INSTALLATION OF CUSHION BARRIER
AT LUNALILO FRWY - VINEYARD (OFF-RAMP)
& STA. 83+00
SAFETY IMPROVEMENTS ALONG
INTERSTATE H-1
KALIHI ST. TO PALI HIGHWAY
Proj. No. I-HI-1(112):19 Date: April, 1973

STATE OF HAWAII
DEPARTMENT OF TRANSPORTATION
HIGHWAYS DIVISION
INSTALLATION OF CUSHION BARRIER
AT LUNALILO FRWY. & RAMP "5"
@ Sta. 103+50
SAFETY IMPROVEMENTS ALONG
INTERSTATE H-1
KALIHI ST. TO PALI HIGHWAY
Proj. No. I-H-1(112)19 DATE: April, 1973

C. O. 45

SAFETY IMPROVEMENTS ALONG
INTERSTATE H-1
KALIHI ST. TO PALI HIGHWAY

Scale: 1" = 1'-0"

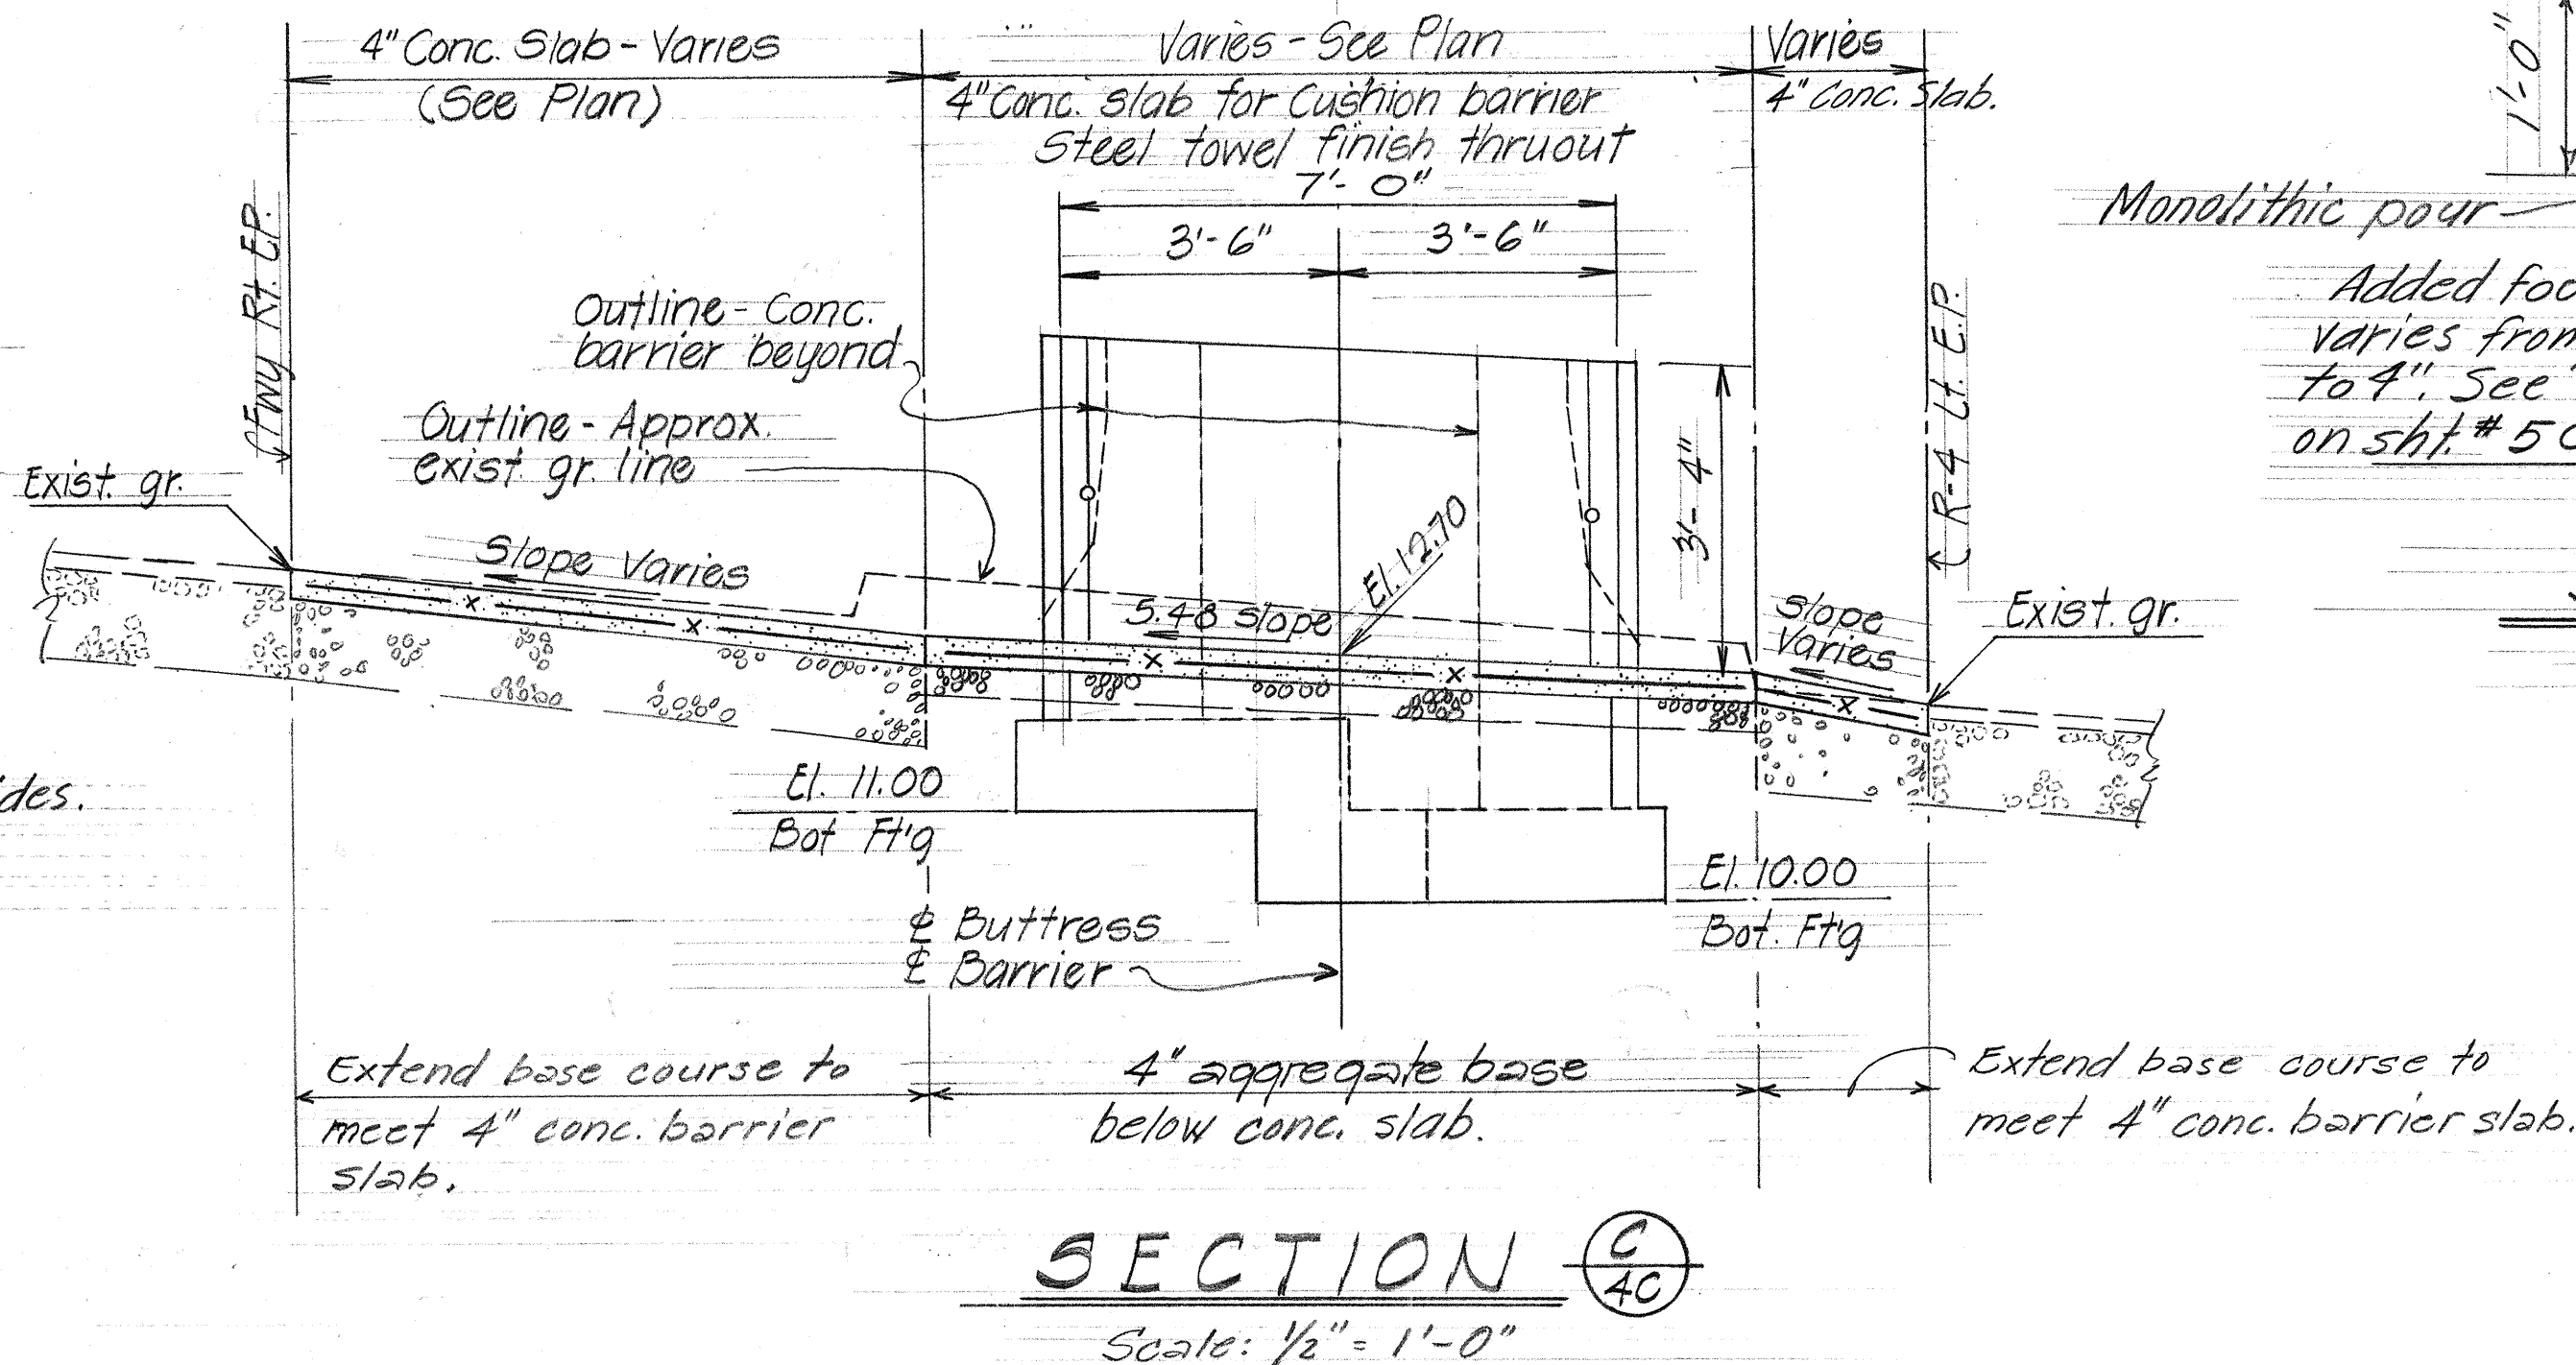
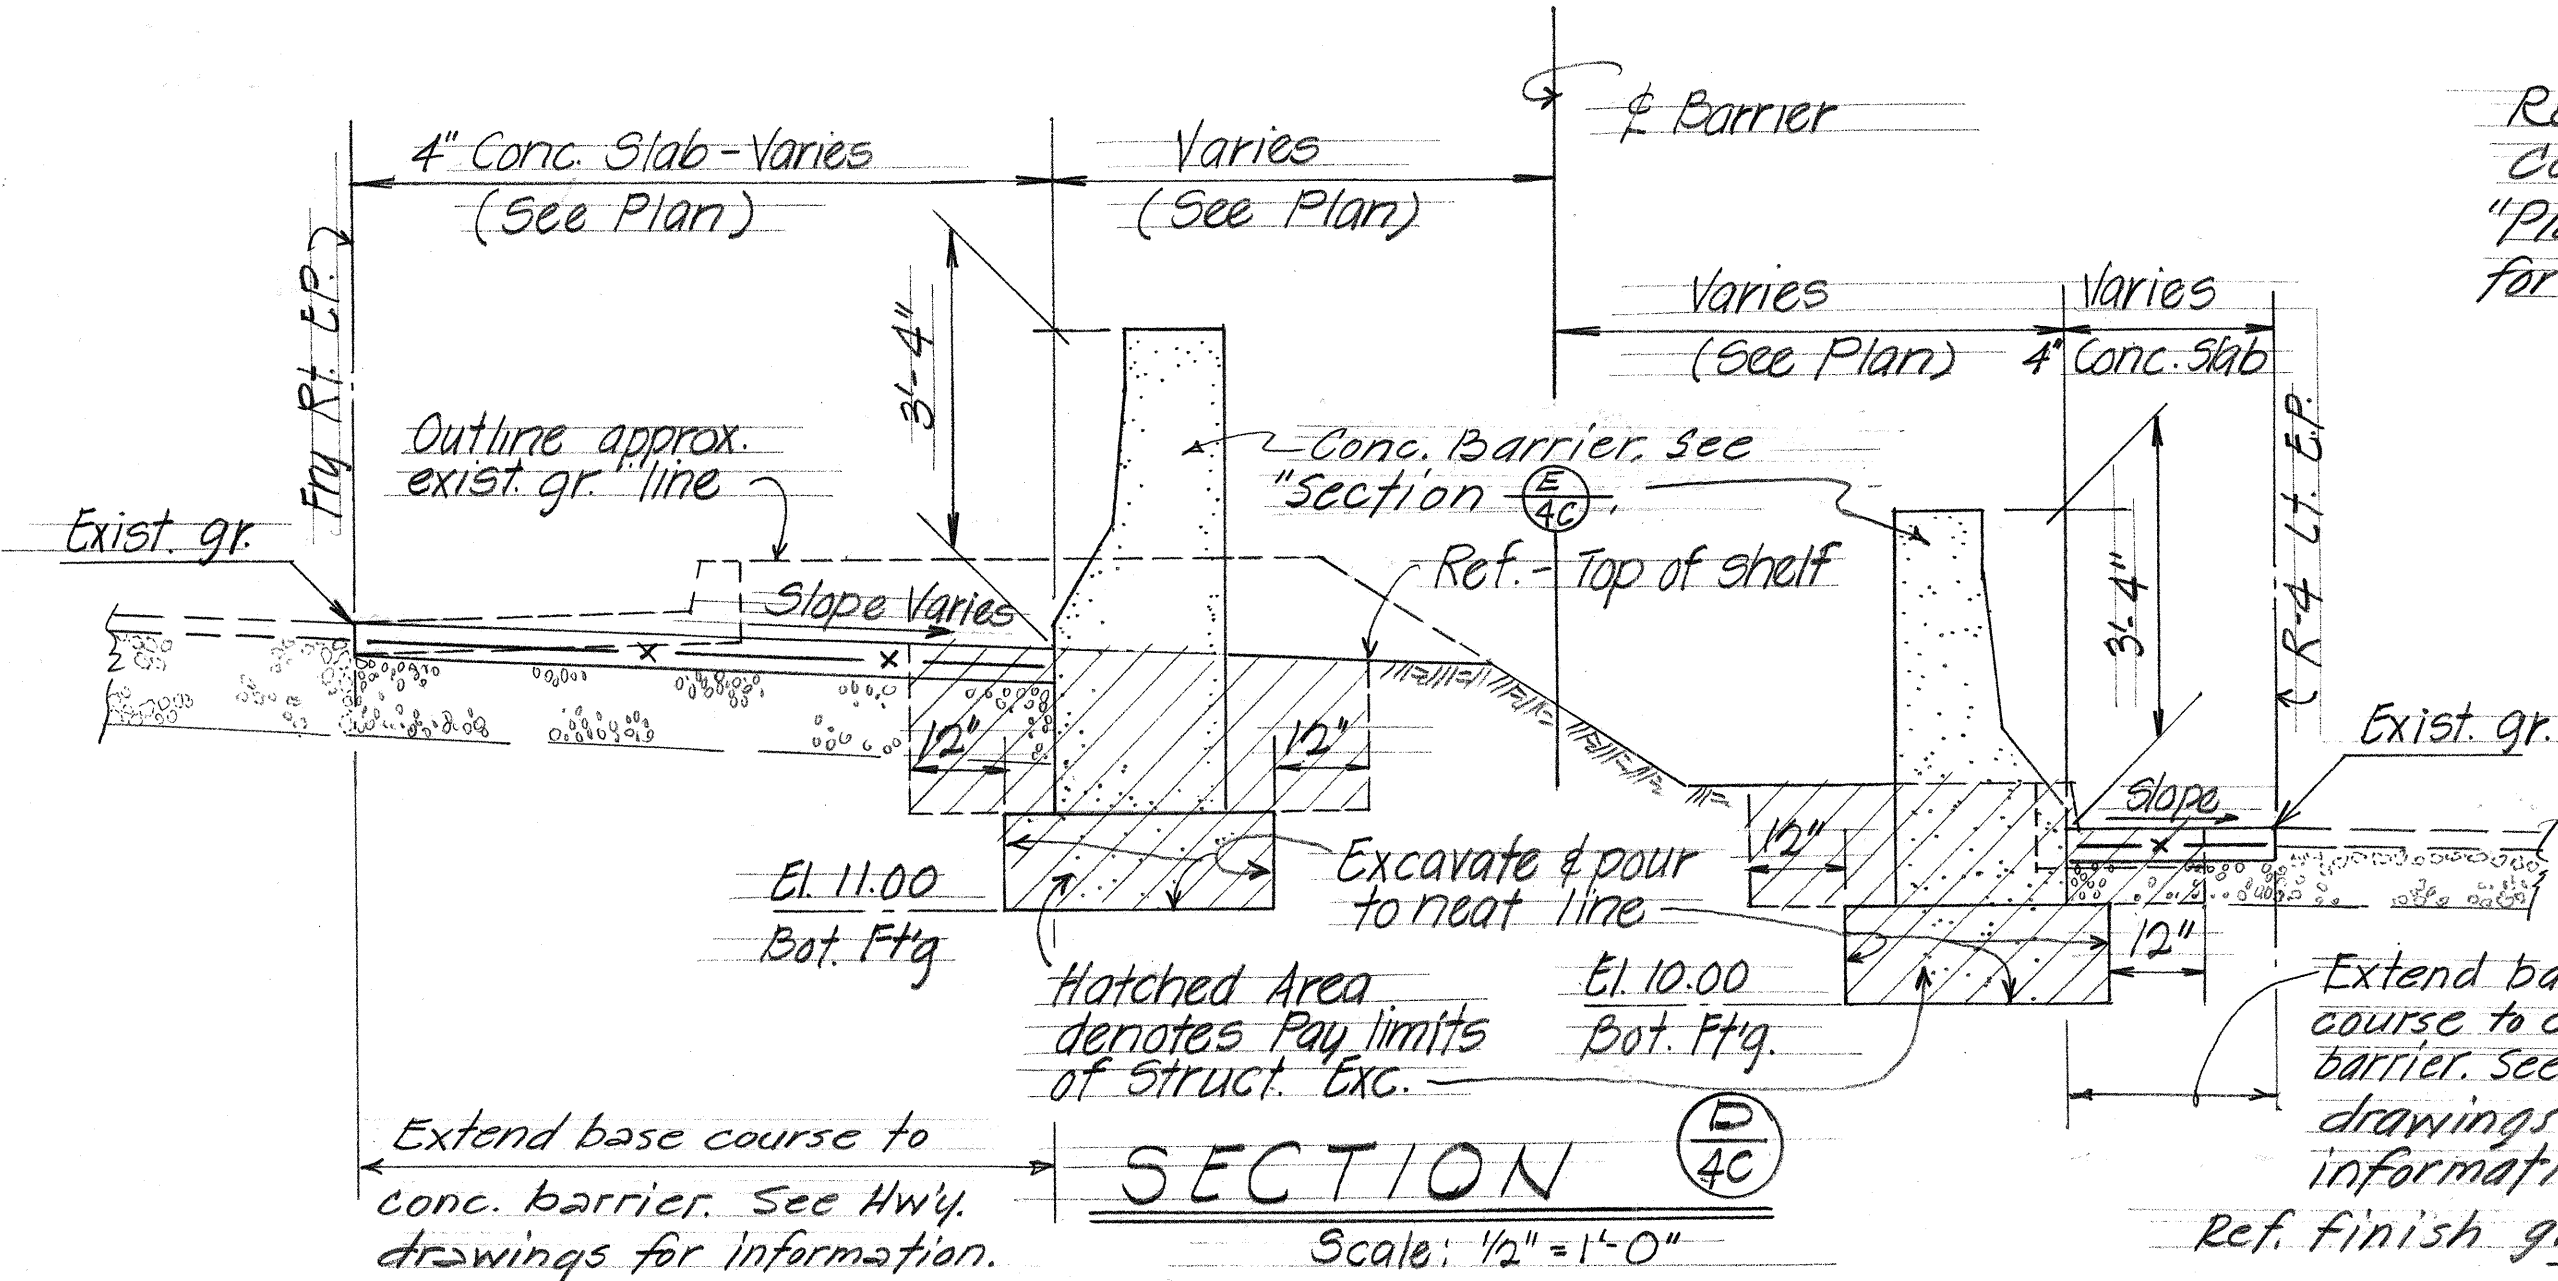
11-27-'74 Buttness width increased from 6' to 7'-0" due to modification of cushion barrier system. Adjoining concrete barrier revised to match revised buttness.
